Statement of Community Involvement

Land at Moorthorpe Way (Site E), Owlthorpe, Sheffield

**Prepared by
DLP Planning Ltd
Sheffield**

Site Address: Owlthorpe E updated layout	Pre-app enquiry ref: 19/02510/PREAPP
1. We understand your proposal to be.... Revised layout Option 2 – 007_02_ Rev G

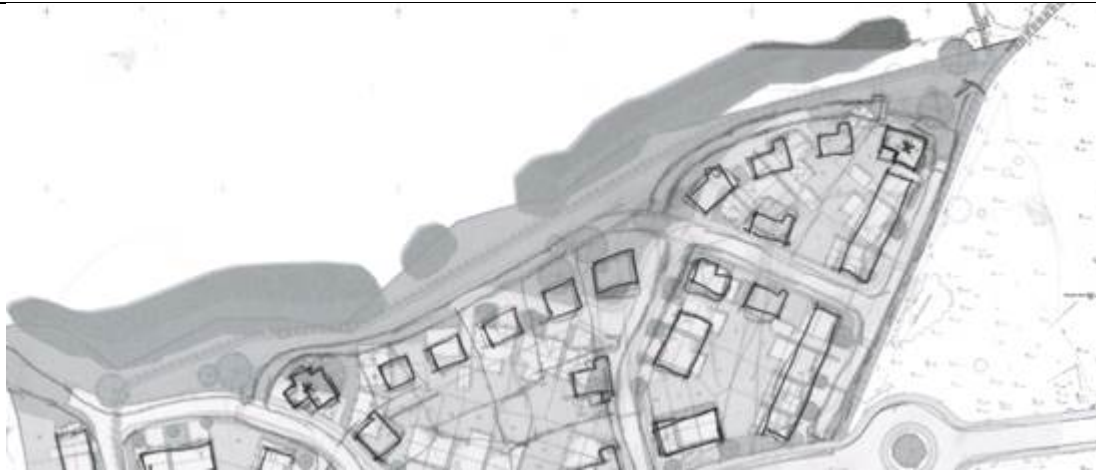
2. Advice¹ In this section we will say what we think about your proposal. This will include our view about the likelihood of permission being granted and what might be done to improve the prospects, where relevant. The revised layout has addressed some of the comments previously made on 11.6 but we would recommend that the following points are given further consideration 1. Woodland edge The layout appears too loose as currently proposed, and has a lot of ‘left over’ green space. We acknowledge the setback required-although the plan needs to show more clearly where the 15 M line is located. A response could be to have a drive/ road along the woodland edge outside the 15m line as achieved in other locations- for example Norfolk park housing company sites, as was illustrated in the planning brief as an option. Introducing this along with adjusting the main access road will allow for a fuller cluster of development.
